TITLE: LARGE OPTIC SUSPENSION ASSEMBLY (LOS1d) FOR INPUT TEST MASS, 2K (1TM, 2K)

REDLINE

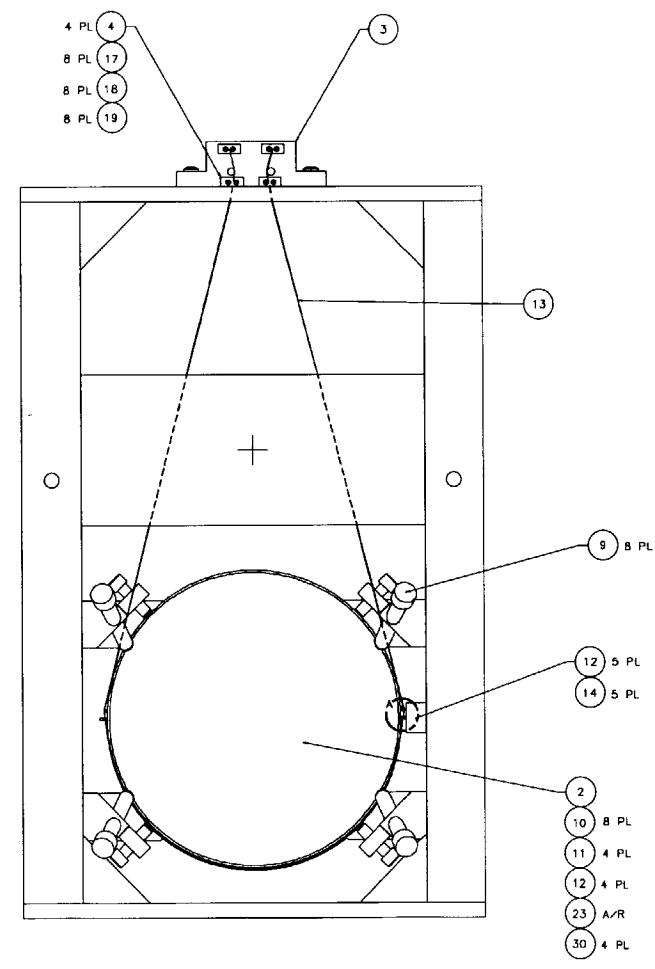
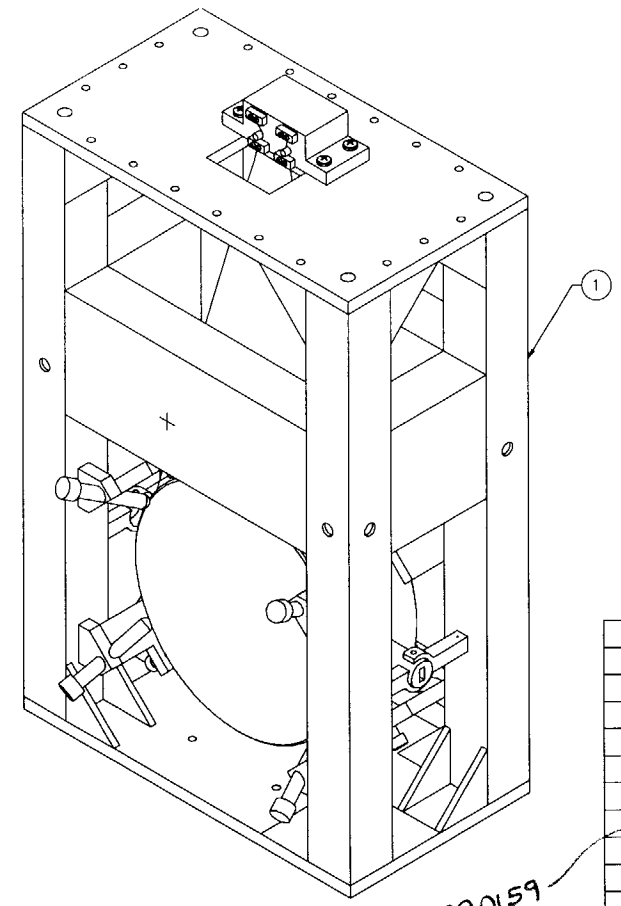
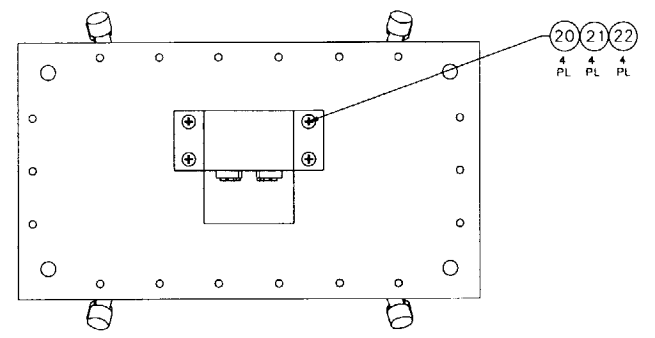
NOTES: (UNLESS OTHERWISE SPECIFIED)
 1. SPECIFICATIONS FOR THE CONSTRUCTION OF THIS ASSMBLY ARE COVERED IN THE LARGE OPTIC SUSPENSION BALANCING SPECIFICATION, LIGO E970154.
~~MATERIAL: CONDUCTIVE TEFLON, MANUF. BY FURON DIXON, 385 METACOM AVE., BRISTOL, RI, 02809, (401)253-2000, AND DESIGNATED BY THE NAME FURON DIXON COMPOUND 1042.~~
 HEIGHT ADAPTER IS NOT SHOWN FOR CLARITY. IT IS BOLTED TO THE TOP OF THE LOS STRUCTURE ASSEMBLY USING THE HARDWARE ITEM NOS. 25-28. INSTRUCTIONS INCLUDED IN LIGO E970154.
